# UNITED STATES PATENT AND TRADEMARK OFFICE

APPLICATION NO.	FILING DATE	FIRST NAMED INVENTOR	ATTORNEY DOCKET NO.	CONFIRMATION NO.
09/321,633	05/28/1999	JAMES W. KENNEY	E-1901	6762

# Office Action Summary

## DETAILED ACTION

FIG. 20

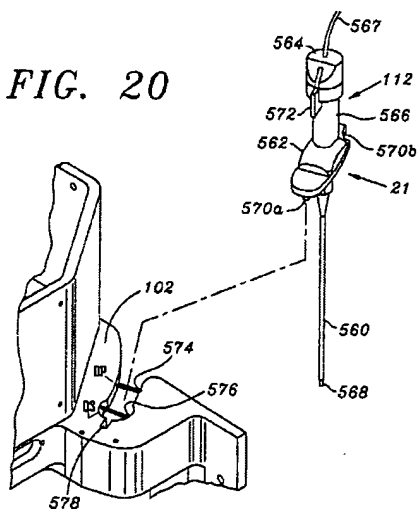
Additionally, this switch, through the microprocessor 43, automatically activates/deactivates the air pressure source. Kenney fails to teach a gun holster arranged to support the gun above the worktable. Goodale *et al* teach a pipette holster used to support the pipette 112 above a worktable in a vertical direction. Goodale *et al* teach a mounting bracket 102 having a fork with prongs 574 and a circular socket 576 constructed to removably hold the pipette. Wherein the socket is formed between the prong and has a diameter (DS) which is larger than the distance between the prongs (DP), (column 11, line 61- column 12, line 28, and modified Fig. 20 below.) The opening 576 is smaller in diameter than the head 564 such that the pipette probe 112 may be supported by the head 564 within the opening 576, the key 572 and keyway 578 cooperating to align the pipette probe 112 within the opening 576 and thus with respect to the frame 102. Such use of a bracket insures that the pipette tube does not touch anything and will remain sterile. Given this teaching, it would be obvious to one of ordinary skill that the pipette connector 564 and barrel 566 is inserted from the top such that it engages the socket 576.

Accordingly, it would have been obvious to one of ordinary skill in the art at the time of the invention to have included in the dispensing means of Kenney, the pipette holster, as taught by Goodale *et al* in order to insure that the pipette tube does not touch anything and will remain sterile while remaining securely restrained within the mounting bracket (column 2, lines 35-57 of Bale *et al* (USP 5,704,495)).
